## ADDENDUM

**Project:** Enger Tower Gazebo **Project No.** 10075.03  
**Owner:** City of Duluth  
**Architect:** Collaborative Design Group  
100 Portland Ave South, #100  
Minneapolis, MN 55454  
(612) 332-3654; FAX (612) 332-3626  
**Addendum:** No. 04 **Date:** 08/22/2011

**1 SECTION @ GAZEBO**  
 A400 SCALE: 1/2" = 1'-0"

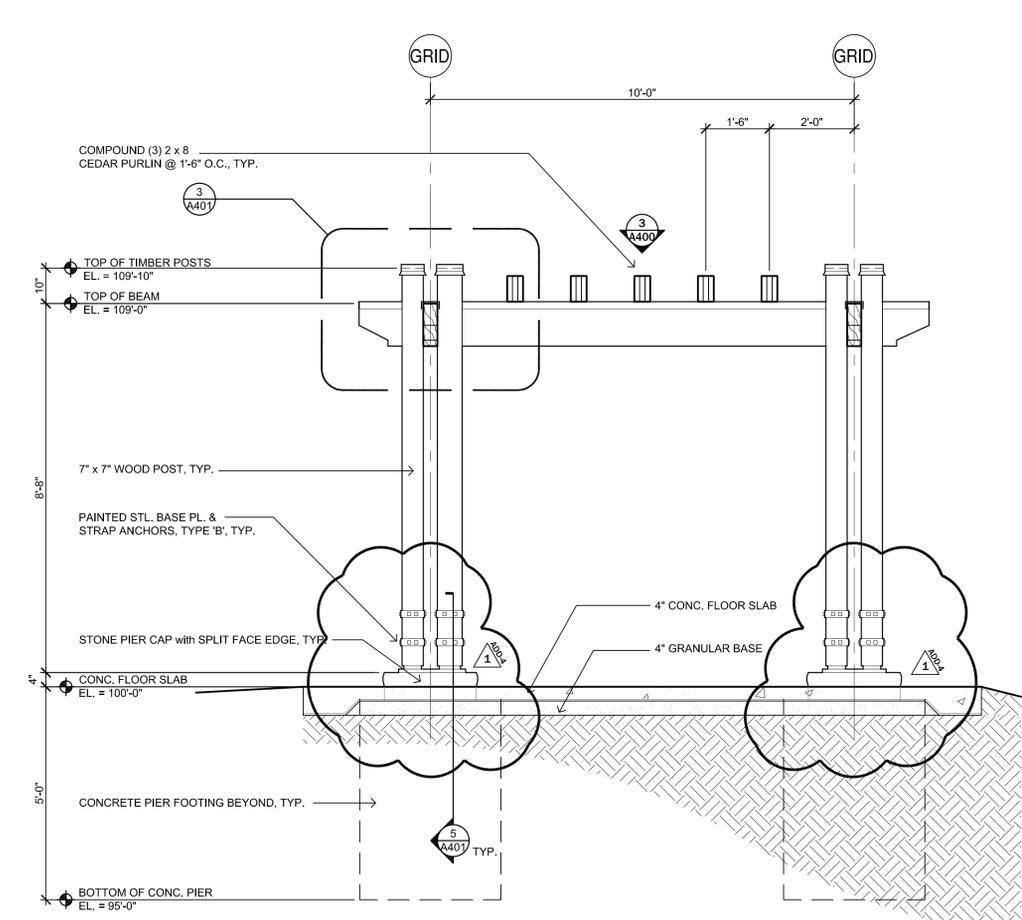
- Drawing 1 – Remove “Metal” reference at shingles;
- Drawing 2 - Add note designating pergola as being Deduct Alternate 3; modify pergolas to indicate elimination of stone piers (stone caps to remain).
